Air Quality Specialist Response

RE: Response to Agency Submissions for Rix's Creek Continuation of Mining Project

Appendix H-2 Response to additional queries from the NSW EPA

RE: Rix's Creek Coal Mine Extension Project - Response to Environment Protection Authority's Air **Quality Assessment Review RTS**

Figure 1: Predicted 6th highest 24-hour average PM₁₀ level for all years assessed

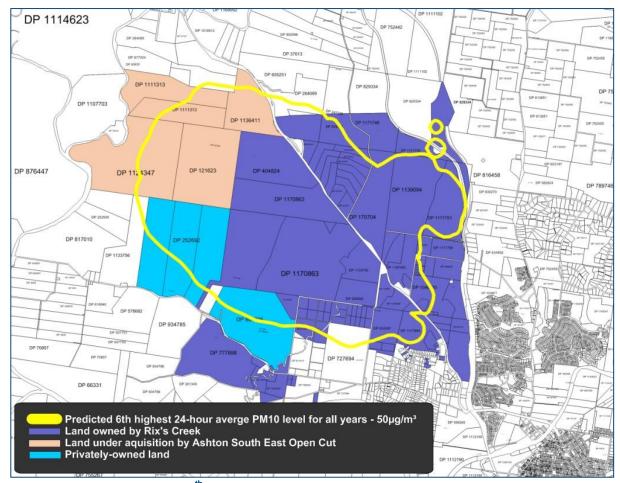
"The cumulative assessment finding that six non-mine receptors are expected to experience additional days above the 24-hour PM₁₀ criterion should be included in the summary in section 16 and the Executive Summary"

The maximum extent of the 6th highest 24-hour average PM₁₀ impact due to the Project in isolation with the predicted impact due to the reduced schedule during Year 2023 is presented in Figure 1. The result indicates that the conclusions presented in Section 9.7 of the AQA would not change.

Figure 2: Sensitive receptor locations assessed in the AQA

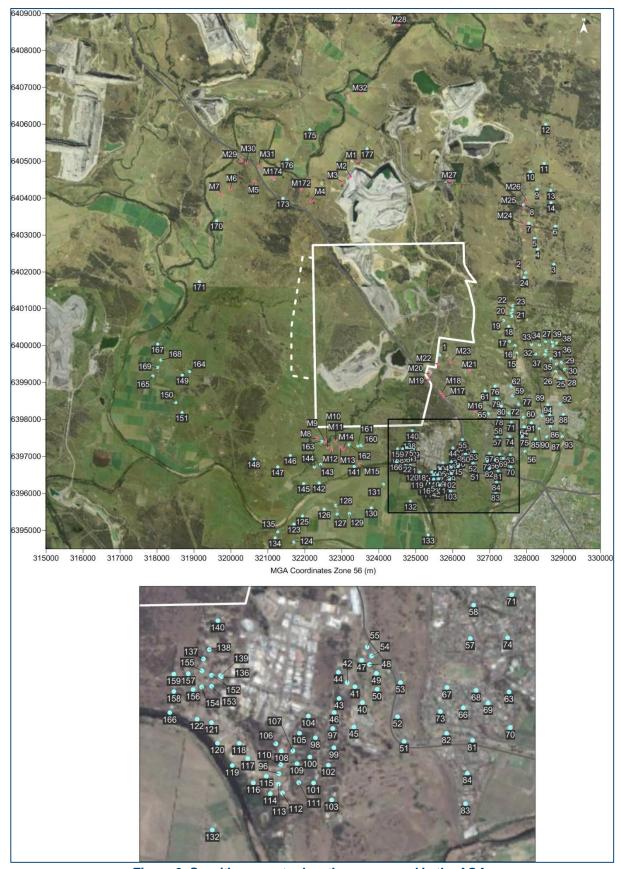
A clarification of the AQA has been identified with regards to the sensitive receptor locations presented in Appendix B of the AQA. In Figure B-1 of Appendix B of the AQA, the mine owned receptors labelled as M5 to M33 are incorrect and should be labelled from M4 to M32.

We also note that the receptor labelling in the figures of Section 11 of the EIS are also incorrect.

The correct receptor labelling is presented in Figure 2.

Figure 3: Predicted 24-hour average PM₁₀ concentrations for Receptor 45 in Year 2017 and 2020

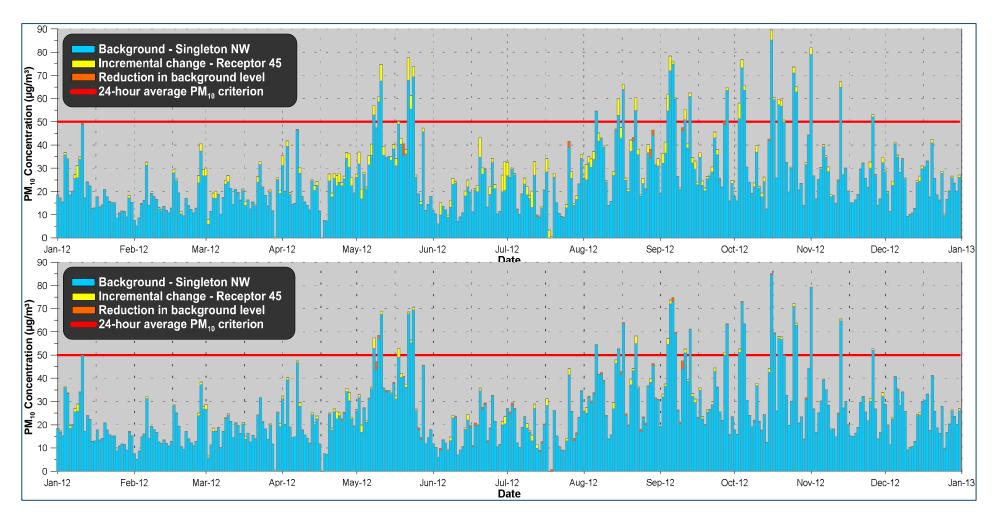
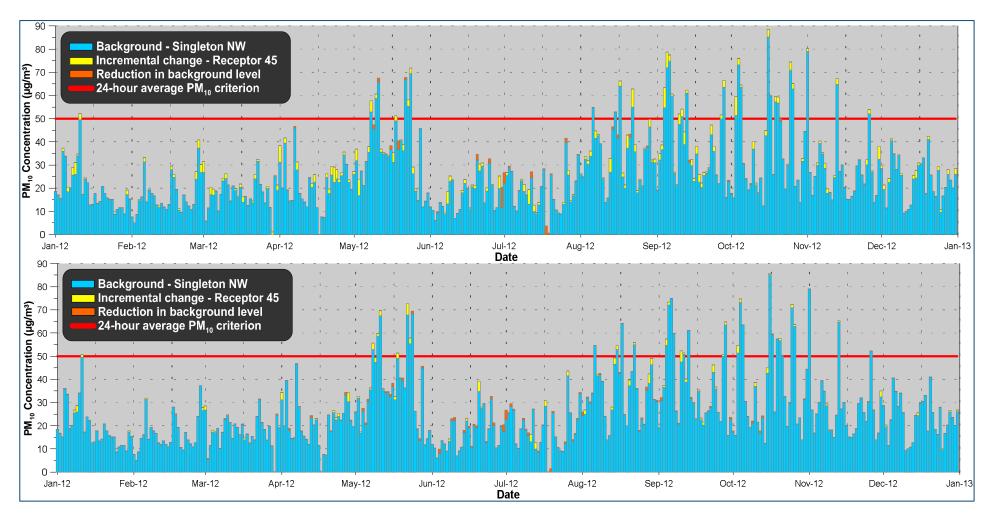
"Country Acres Caravan Park at 58 Maison Dieu Road lies to the south-west of the proposed pit expansion and within 500 metres. It does not appear to have been assessed as a receptor. Maitland Diesel Service is located on Rix's Creek Lane and also does not appear to have been assessed as a receptor. The EPA requires the potential impact at these receptors to be assessed."

A contemporaneous PM₁₀ assessment per the NSW EPA Approved Methods has been performed for the Country Acres Caravan Park (Receptor 45) to determine the extent of potential impacts at this location. A summary of the findings of the contemporaneous assessment is presented in **Table 6**. A time series plot of the 24-hour average PM₁₀ concentrations is presented in **Figure 3** and **Figure 4**.

The time-series plots presented in **Figure 3** and **Figure 4** indicate that **Table 6** is not an optimal indicator of potential impact. The plots show a general decline in overall impacts over time.

Figure 6: Incremental 24-hour average PM₁₀, existing mine 2012 (blue) vs. Project worst case year 2023 (faded yellow) vs. Project reduced schedule year 2023 (orange)

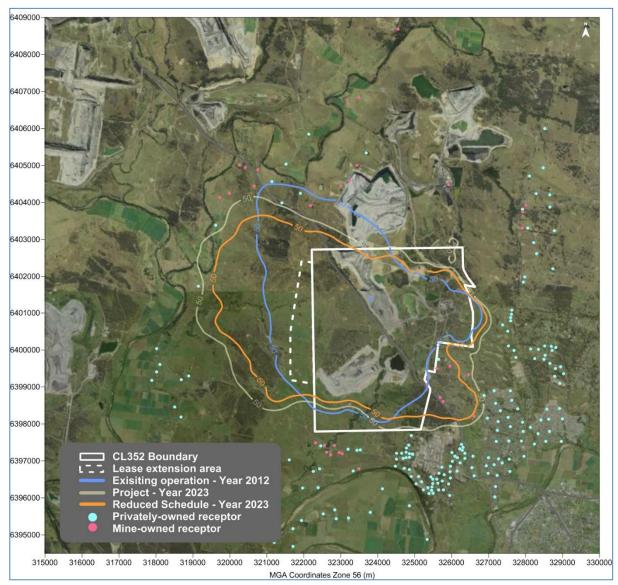
"Council is currently considering a Planning Proposal seeking to rezone land to residential in North Singleton, west of Bridgeman Road and north of Gardner Circuit. While it is acknowledged mining operations are moving away from Singleton it is not clear from the EA the extent of, if any, noise impact on this area having regard to future residential land uses."

Figure 6 shows that for the worst case year assessed, the impacts from the mine would increase in the area proposed to be subdivided.
